**ISOLITE**

Reference: Your letter of February 26, 2007  
 Docket No. 030-37392  
 Control No. 139970

We respond to your request for additional information concerning our recent license application below. In addition, we enclose Revision #1 of our Application to Possess Radioactive Materials. This revision includes the necessary modifications to comply with the issues raised in your letter.

**Addendum to USNRC FORM 313**  
**Application to Possess Radioactive Materials**

Figure 1 - Ground Floor of Isolite Facility, Berwyn, PA

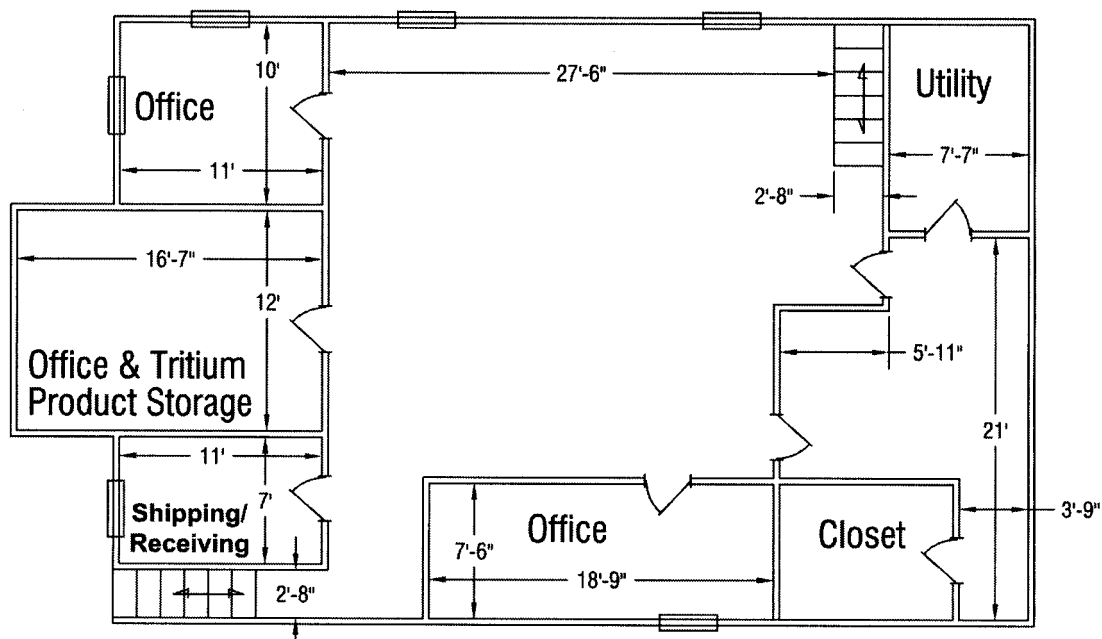
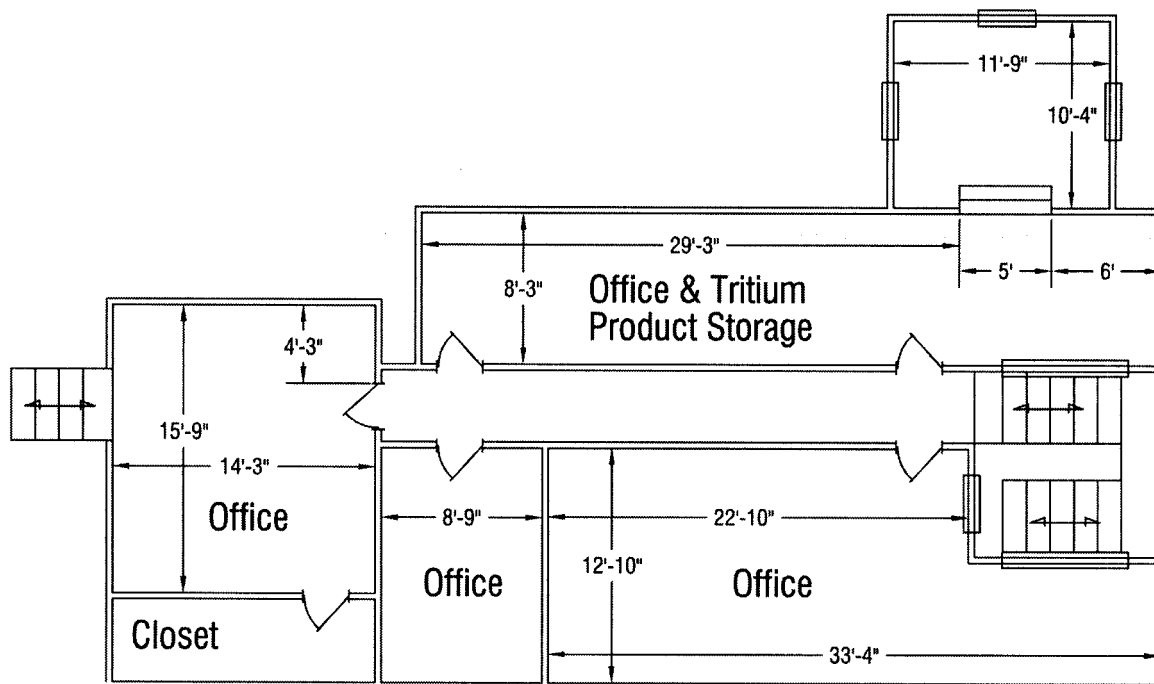
- 14. Item 9 of Revision #1 has been modified to show shipping and receiving areas and has been drawn to scale.
- 15. Item 10.1 of Revision #1 has been modified consistent with your request.

The tritium products storage rooms are located on the ground floor of the Berwyn facility (see Figure 1 below) and on the 3<sup>rd</sup> floor (see Figure 2). The exempt gun sights are stored in the ground floor room on shelves in plastic bags organized by part number. Generally-licensed products are also stored in this room or in the storage room / office on the 3<sup>rd</sup> floor. These rooms are locked
